**RE: RESPONSE TO RESOLUTION OF JOINT REGIONAL PLANNING PANEL MEETING  
2012HCC019 – DA 2012/0549 – 1 KING STREET, NEWCASTLE**

<b>Current Lodged Plans</b>	<b>Proposed Replacement Plans</b>
DA 004 Issue M	Drawing A211 Issue N
DA 005 Issue M	Drawing A212 Issue P
DA 006 Issue N	Drawing A213 Issue P
DA 007 Issue P	Drawing A214 Issue Q & A201 Issue N
DA 008 Issue R	Drawing DA008 Issue S & A202 Issue N

SUPPLEMENTARY TRAFFIC REPORT  
(RESPONSE TO TRANSPORT  
MATTERS) FOR THE PROPOSED  
RESIDENTIAL/HOTEL  
DEVELOPMENT – THE ESPLANADE  
PROJECT, NEWCASTLE EAST

A201

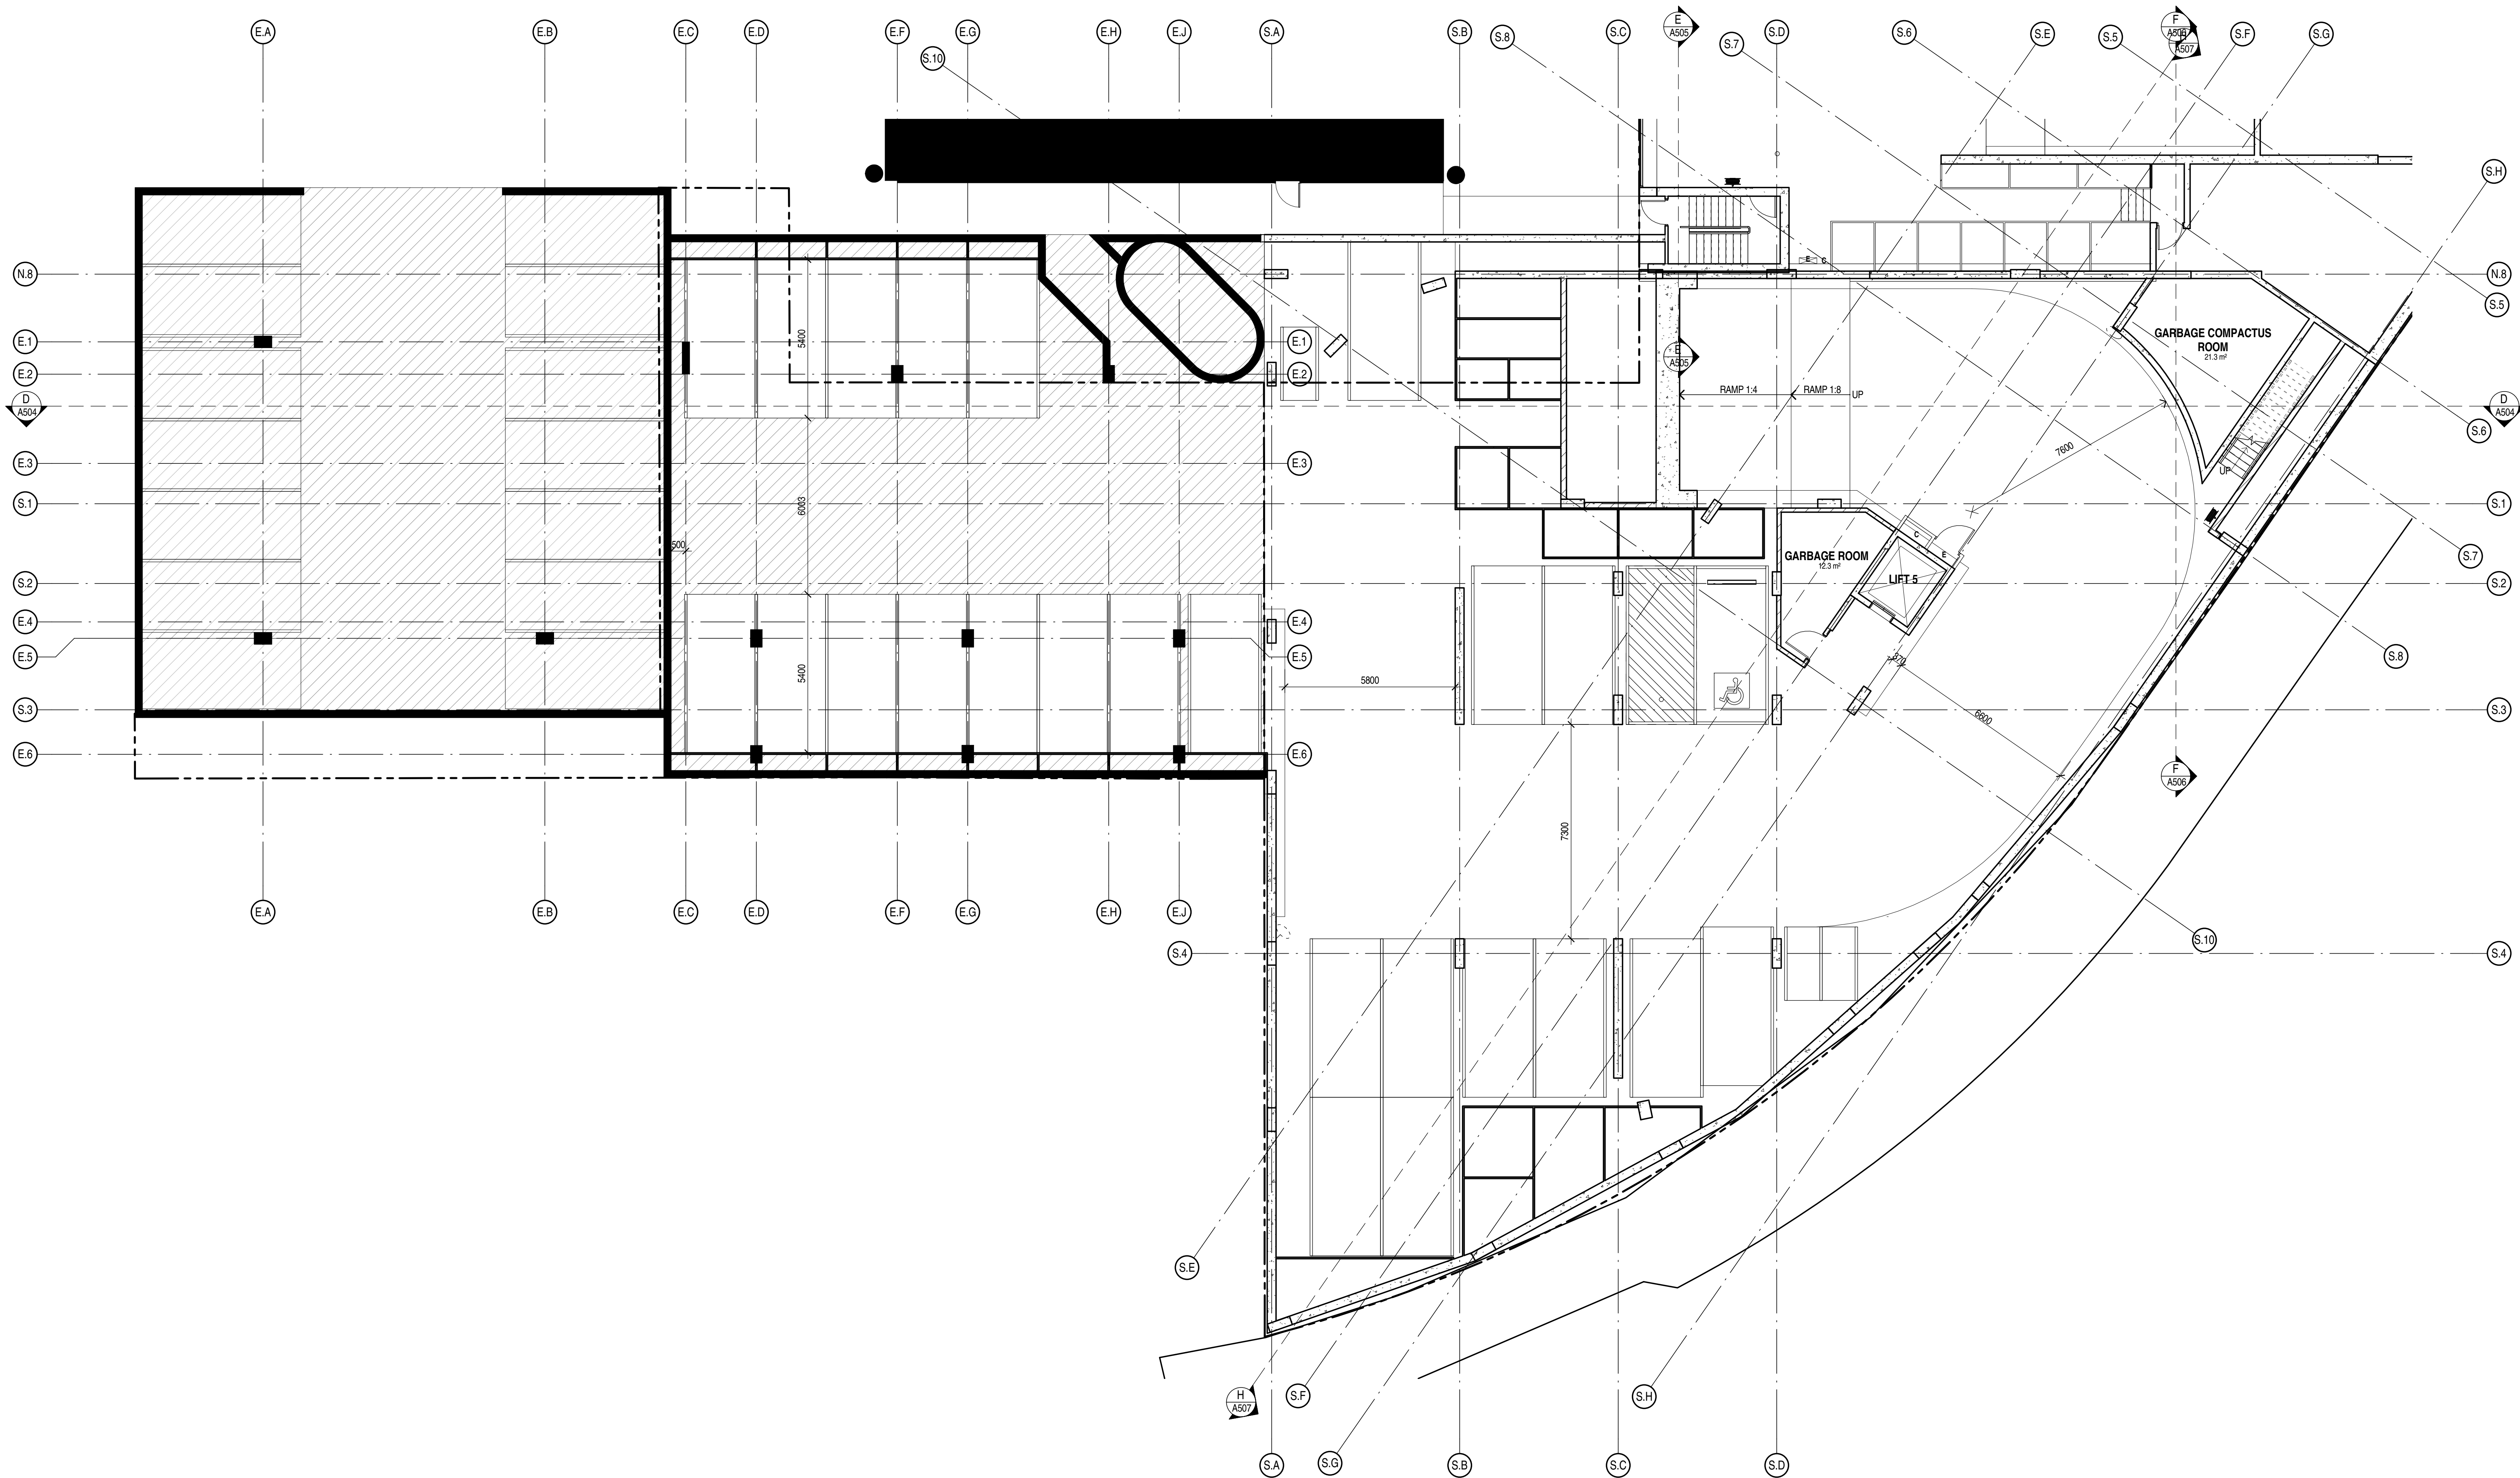
A portion of the hospitality and parking areas shown in drawing DA007P (referred to as "car park level") is located outside the approved Concept Plan building envelope. The first question raised by the JRPP is whether the car park level "complies with" the Concept Plan approval as modified, particularly in relation to whether the proposed hospitality and car parking areas identified on that plan are permitted within the approved Concept Plan building envelopes. This matter has been addressed in general terms in previous submissions to Council and in Council's report to the JRPP, as well as in legal advice obtained by Council and the applicant. We now seek to reinforce this matter specifically in relation to drawing DA007P (as amended by drawings A214 Issue Q & A201 Issue N (Refer to **Attachment 1**)).

- The area of the development shown on drawing DA007P (amended by drawings A214 Issue Q & A201 Issue N) that is outside the modified Concept Plan envelope represents 1% of the GFA of the overall development (as determined by Council). This is a suitable reminder of the minor nature of the divergence and that it should be considered within the context of the overall Concept Plan. It is considered that this small divergence does not cause the development to cease to be generally consistent with the Concept Plan.

Drawing Number  
A214

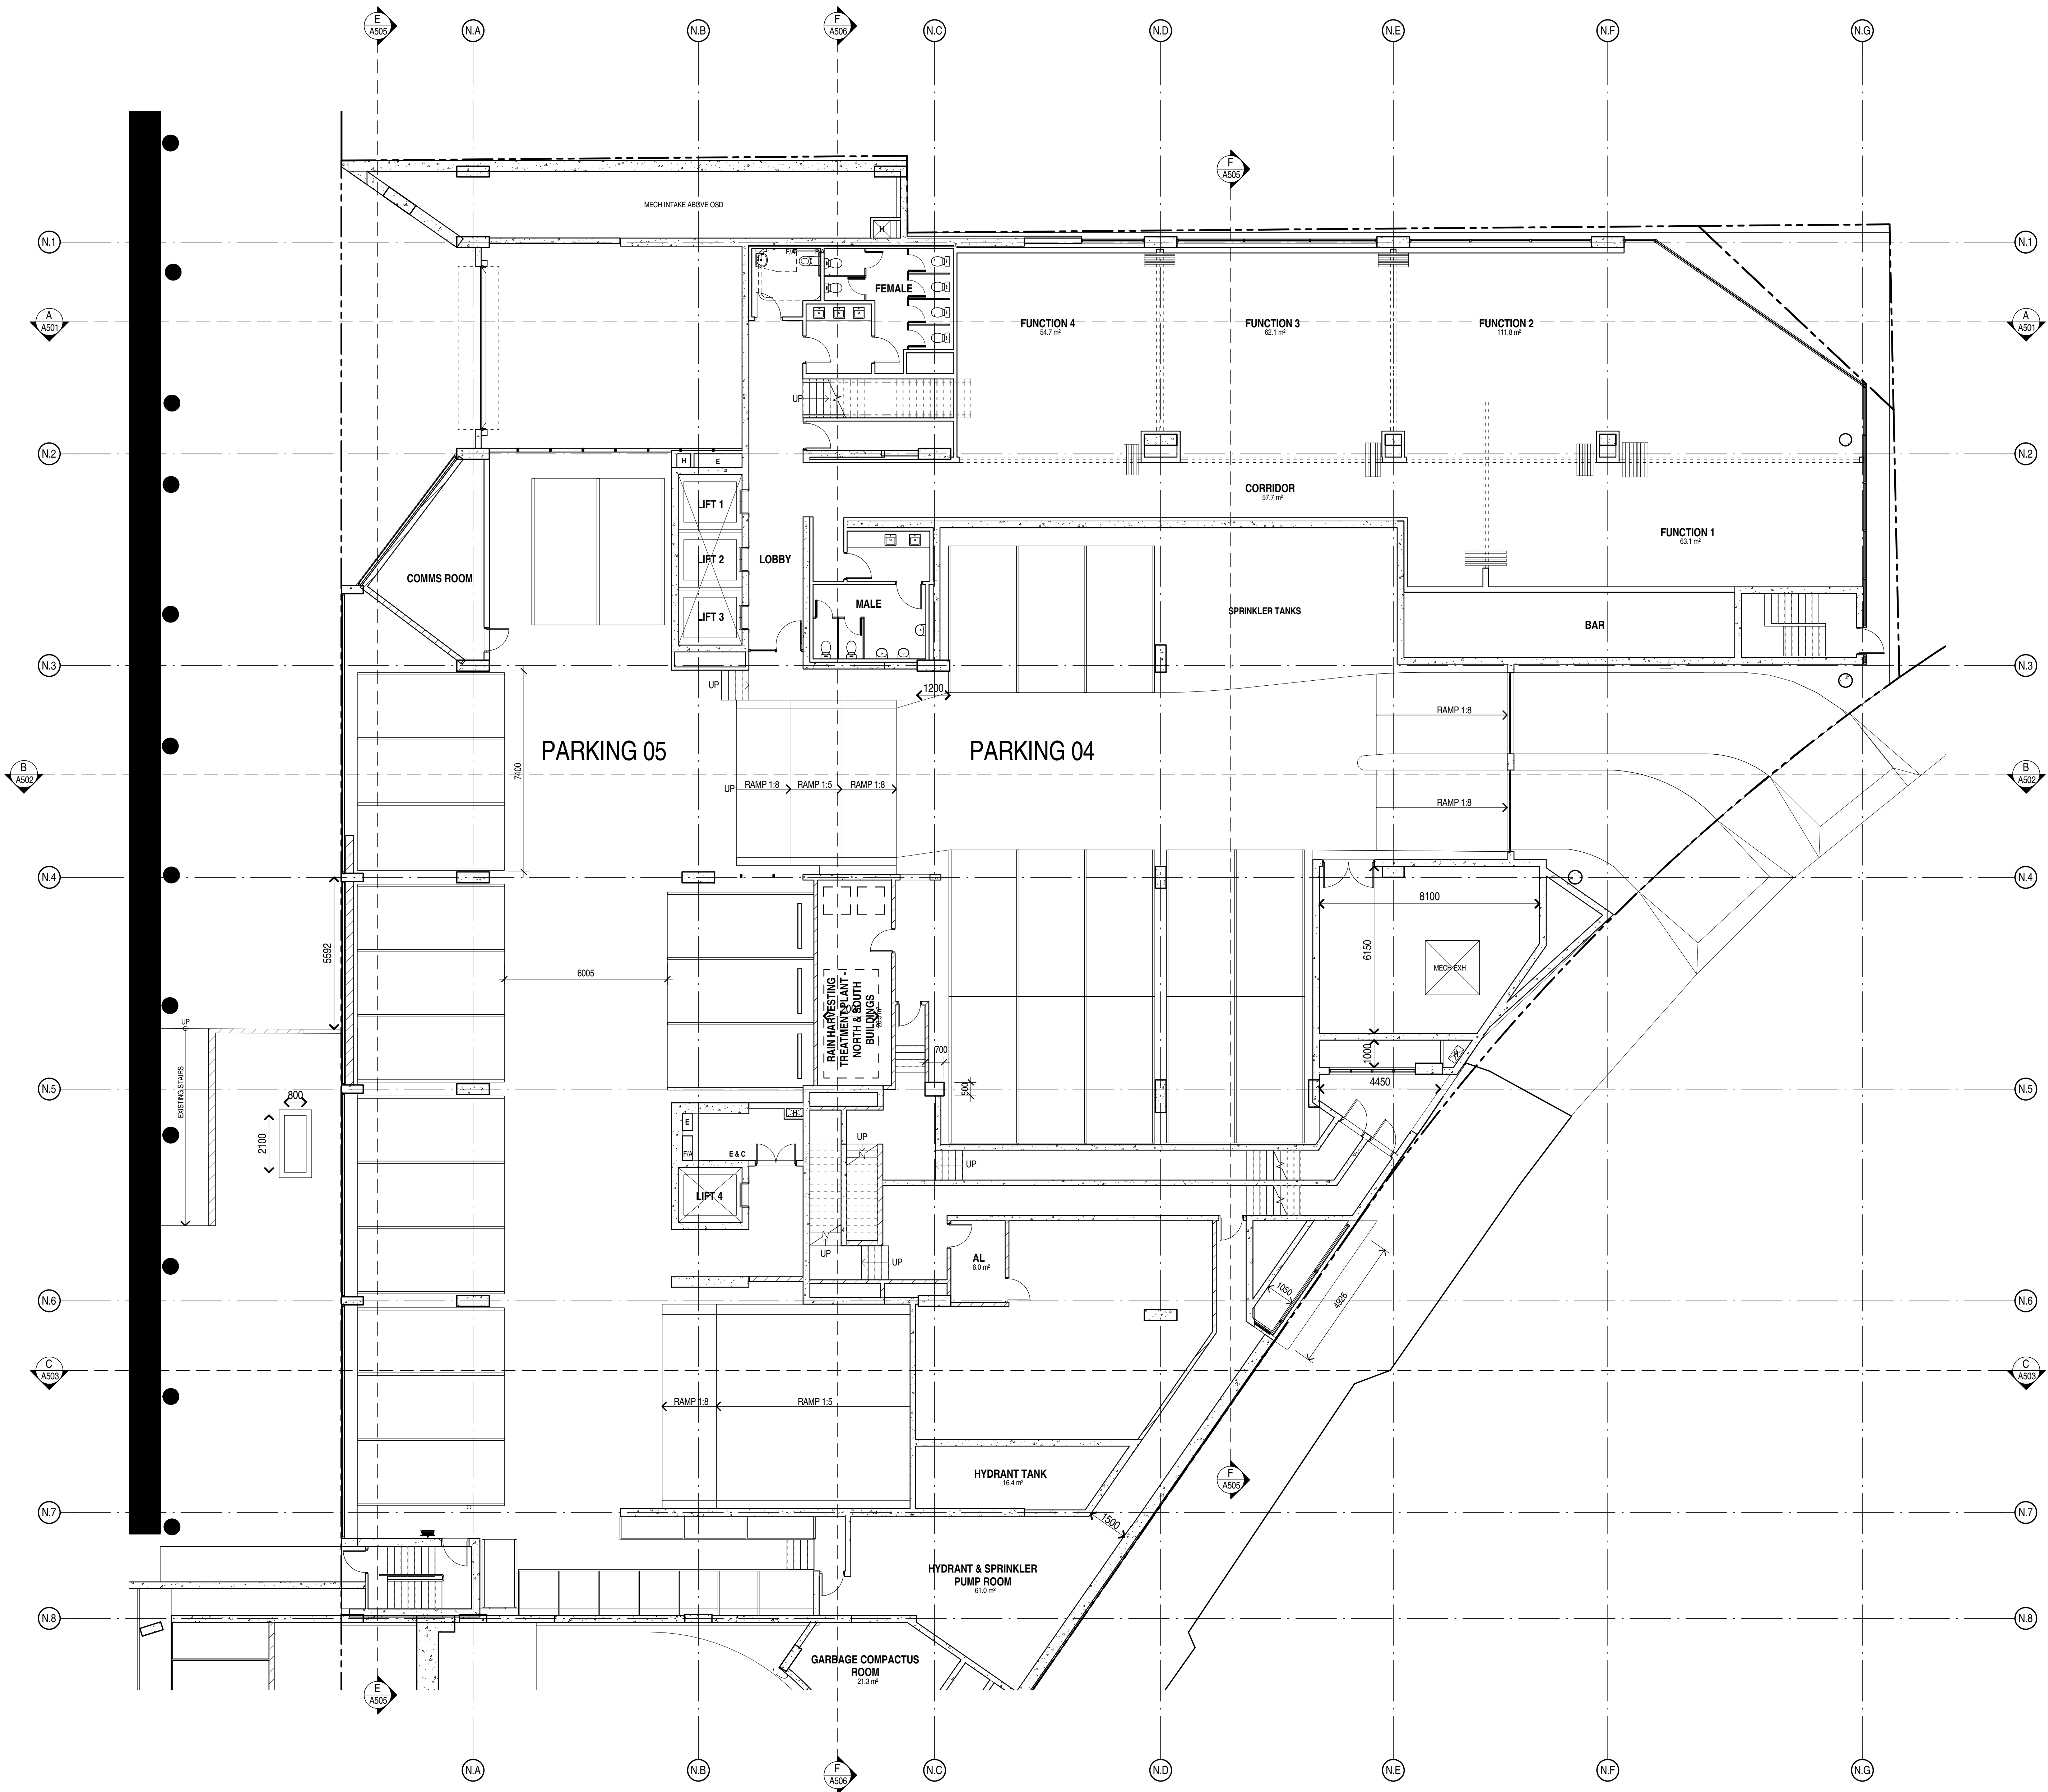
- Separation of north and south building car parks so they operate independently;
- Introduction of Loading Dock;
- Introduction of additional two way entry into north building car park, accessed off The Esplanade;
- Modification of internal ramps to accommodate the above;
- Realignment of services to accommodate the above; and
- Reduction of function space and alteration of orientation to accommodate the above.
